**CITY OF TEMPE
DEVELOPMENT REVIEW COMMISSION**

**Meeting Date: 06/25/2013
Agenda Item: 3**

ACTION: Request for a Development Plan Review consisting of a one-story, +/-11,400 sf. building, a +/-4,536 sf. parking canopy and associated site and landscape improvements for BLUE STAR TRANSPORTATION located at 820 North McClintock Drive. The applicant is Functional Formation Architecture, PLLC.

DPR13128

1
PRELIMINARY SITE PLAN
A1
SCALE: 1" = 20'-0"

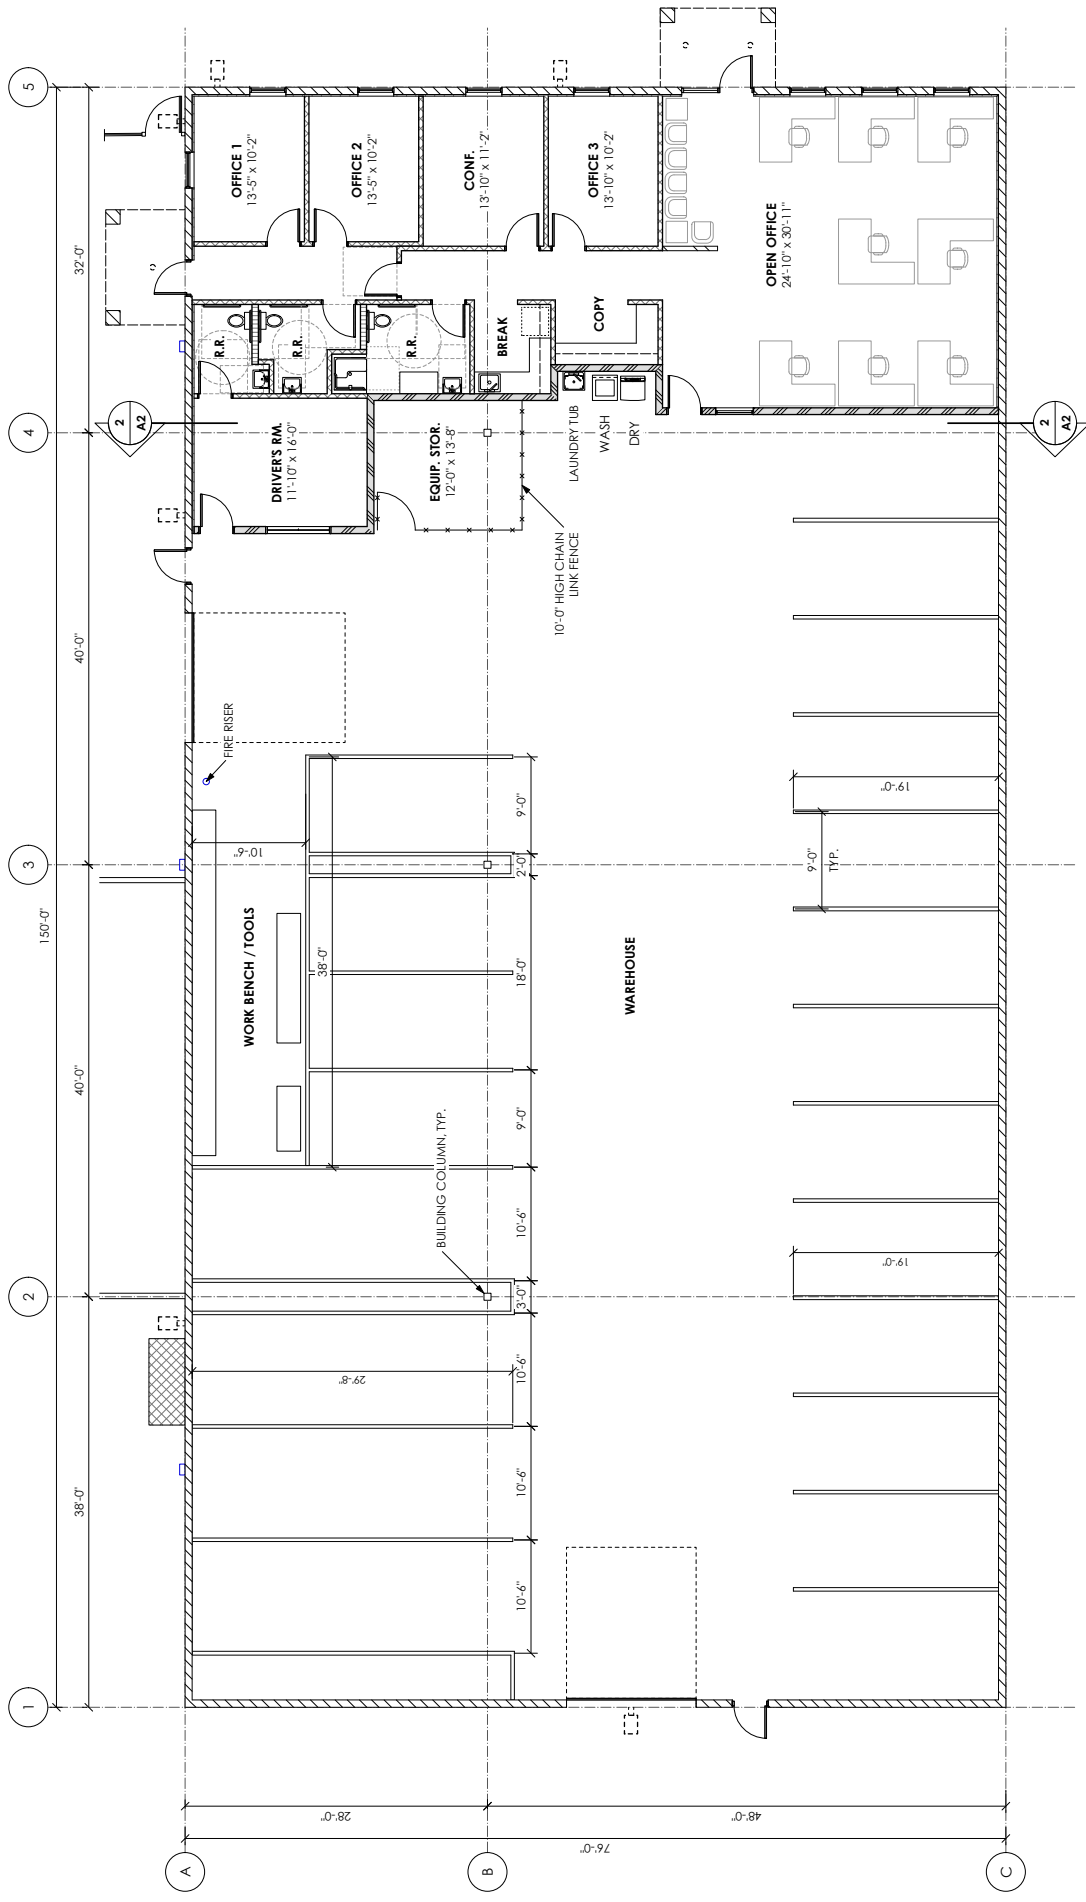
1. Revise vehicle parking calculation to include mezzanine (if any) and exclude thickness of exterior building walls.
2. Striped storage spaces for fleet vehicles in service area, under canopy and in building are not parking and do not have a landscape requirement.

3. Top coat existing pavement in service yard and finish flush with pavement installation for eastern portion of site. Complete this work within two years of Certificate of Occupancy for building.

4. Service yard vehicle entrance: provide 8'-0" high steel vertical picket fence and manually operated vehicle gate facing McClintock Drive. Locate gate as indicated no less than 80'-0" from McClintock Sidewalk bypass. Provide Knox padlock for emergency Fire Department access. Coordinate gate open times with Solid Waste Division for refuse collection. Provide landscape islands with minimum 7'-0" width on one side of fence and minimum 3'-0" width on other side.

5. Service yard pedestrian entrance: Provide gate of steel vertical picket, steel mesh, steel panel or similar construction. Provide gate with optional fixed overhead panel to match 8'-0" fence height. Review gate hardware with Building Safety Division and Fire Department and design gate to resolve lock and required emergency ingress/egress features.

6. Provide 8'-0" tall masonry walls as indicated at north perimeter and south perimeter from rear of building to southwest property corner.
7. On-site screen walls: Provide 6'-0" high service yard masonry screen wall in island to east of septic tank and extend wall from building north to curb. Provide 3'-0" high parking screen walls on either side of driveway along McClintock Drive. Construct refuse container pad in the service yard per standard detail DS-116 except delete the refuse enclosure wall.

11. Provide shade canopy for fleet vehicle storage with the following requirements:
 - a. Provide minimum 8" deep canopy roof fascia.
 - b. Paint canopy and structure Sierra Tan to match metal work on building.

- c. Conceal lighting conduit in the folds of the canopy structure and finish conduit to match structure.
 - d. Adjust position of canopy in service yard to allow a fire lane loop around west end of the canopy.

12. Indicate five 2'-0" x 6'-0" bike parking spaces and bike parking hoops on site plan. Two bike spaces per bike parking hoop allowed. See ENGINEERING section in Code/Ordinance Requirements for standard bike hoop detail. Provide clearance between bike spaces and adjacent walkway to allow bike maneuvering in and out of space without interfering with pedestrians, landscape materials or vehicles.

1 NORTH ELEVATION
SCALE: 1/8" = 1'-0"

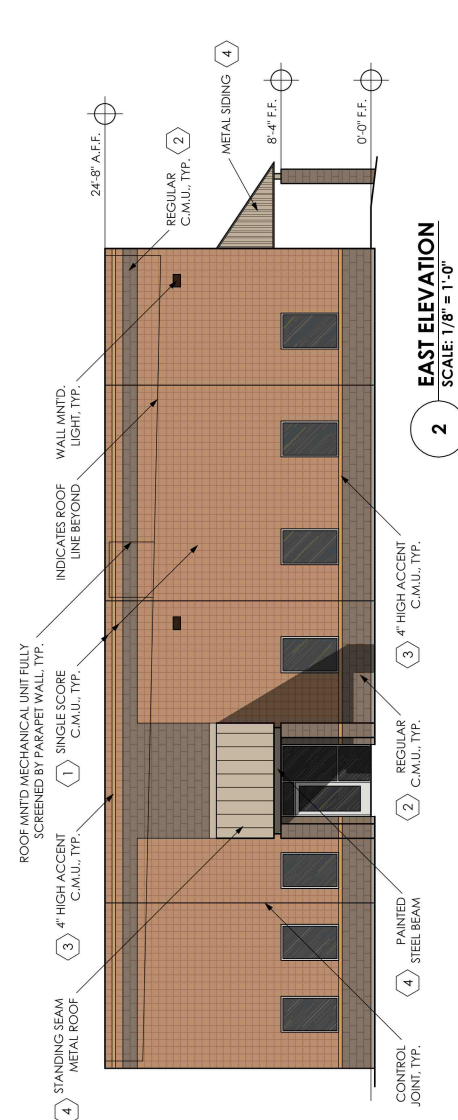
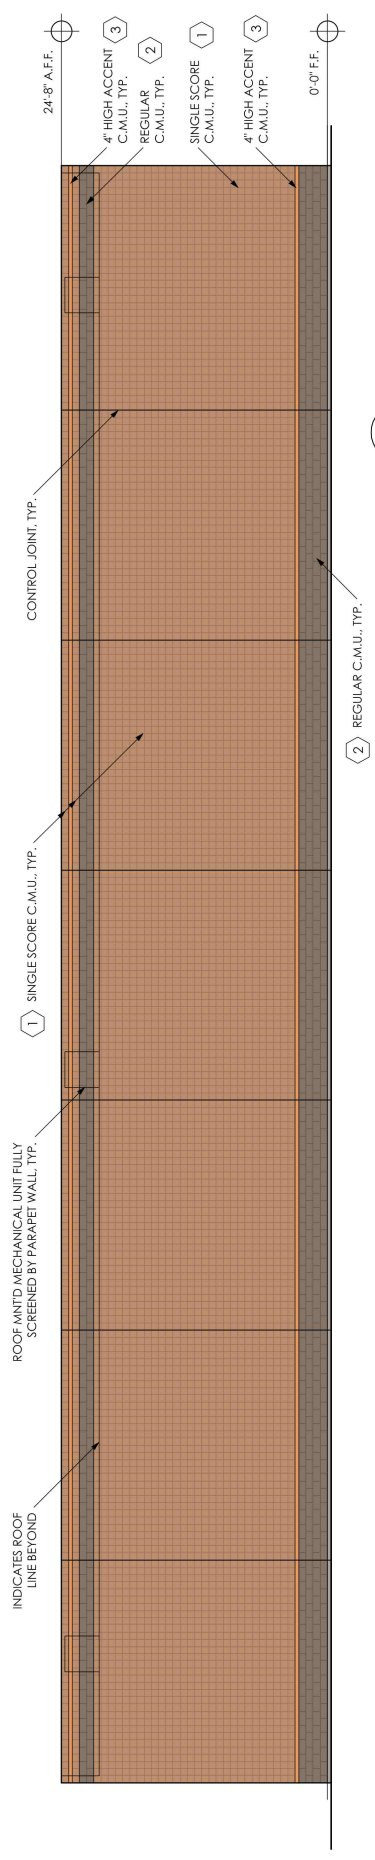
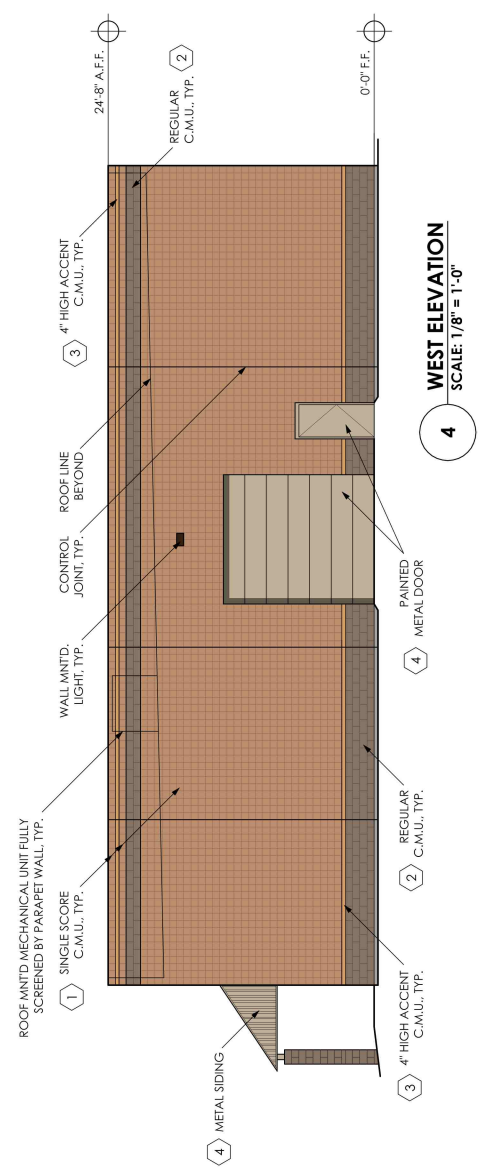
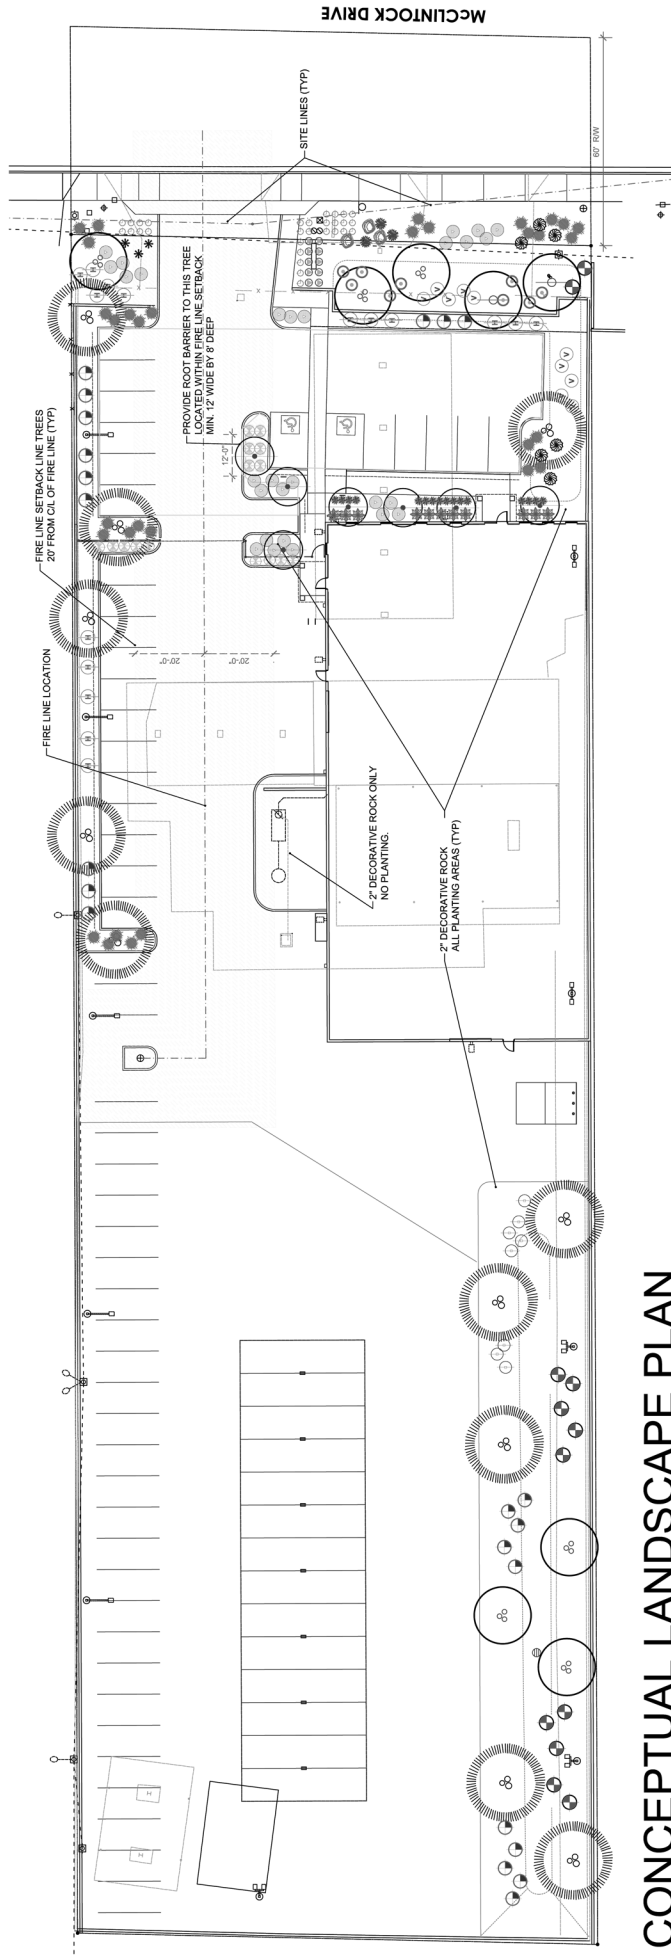
13. Provide a roof plan.
 - a. Provide secure roof access from the building interior. Do not expose ladder or frame to public view.
 - b. For roof mount equipment, indicate on the roof plan spot grades on top of equipment and top of parapet for comparison. Demonstrate the parapet is taller than the equipment. Extend the parapet as required so the roof mount equipment is fully concealed on all four sides.

14. Provide colors and materials as exhibited on the materials sample board and exterior schedule. Additions or modifications may be submitted for review during building plan check process. Provide colors and materials with a maximum light reflectance value of 75 percent.

- e) Glazing: Pittsburg Plate Glass: Solar Cool Gray.
 - f) Storefront Window and Door Frames: Clear anodized aluminum.
15. Expose electrical service entrance section (SES) on north elevation to west of the 6'-0" high screen wall so the SES is located inside the service yard. Paint SES and other surface-mount equipment Sierra Tan to match metalwork on building. Meter panel, irrigation controller and similar metal equipment may also be exposed in this area to west of the 6'-0" high screen wall, but conceal conduit, bus-way and piping all around exterior of building within the building envelope. There is one exception: the irrigation controller valve station and power conduits may be exposed if the controller and conduit are mounted on the west face of the 6'-0" high screen wall, facing the service yard.

16. Surface-mount metal rain water down spouts on north side of building as indicated. Paint downspouts Sierra Tan.
17. Provide security vision panel in each hollow metal door of building elevations. See PLANNING-Elevations section in Code/Ordinance Requirements for materials and size.

18. The divided glass storefront at east entrance is permitted if laminated glass is provided in the lower panel. Laminated glass is not required if an undivided glass panel is proposed between floor and ceiling.
